Declaration of Yan Yan Chew, S.E.
in Support of Comments
on Behalf of the City and County of San Francisco
Regarding Preemption of State & Local Regulation of Broadcast Facilities

ARCHITECTURAL & STRUCTURAL REVIEW COMMENTS

Application # 970664

JOB HDTV ANALYSIS FOR SUTRO TOWER
 CUSTOMER SUTRO TOWER, INC.
 LOCATION SAN FRANCISCO, CALIFORNIA

HDTV STACK AT LEVEL 5 + 6

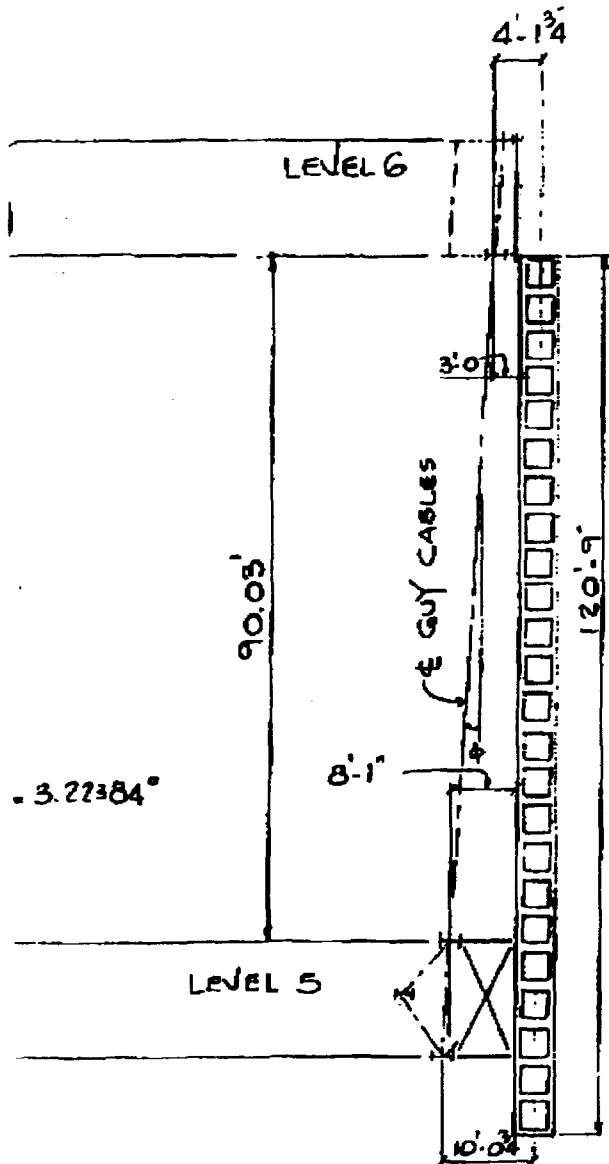
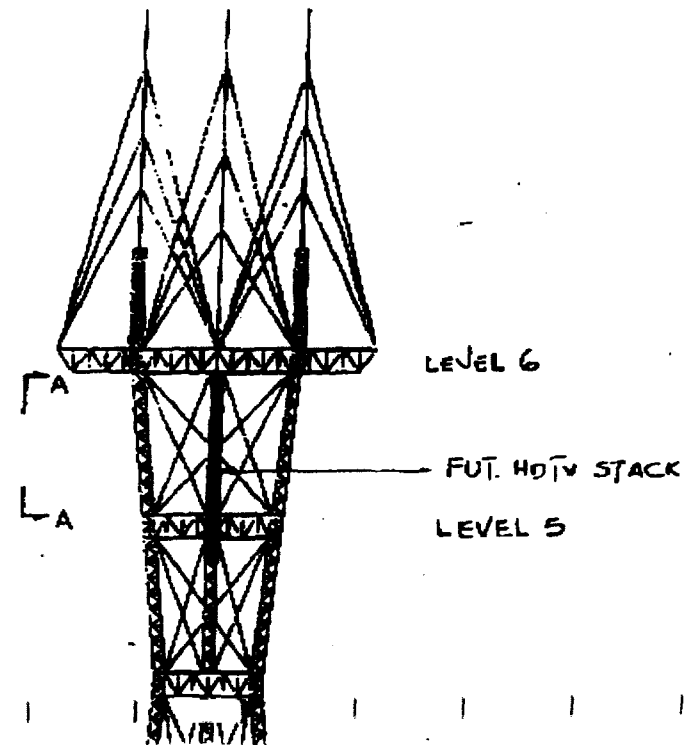
5. I was orally informed by an STI representative that STI plans to install a new beam to support digital transmission antennas at some time in the future. The supplementary documentation STI provided indicated that this beam and the antennas together will weigh 25,500 pounds (more than twelve tons). A true and correct copy of the documentation indicating that the beam and antennas are expected to weigh a total of 25,500 pounds is attached hereto as Exhibit B.
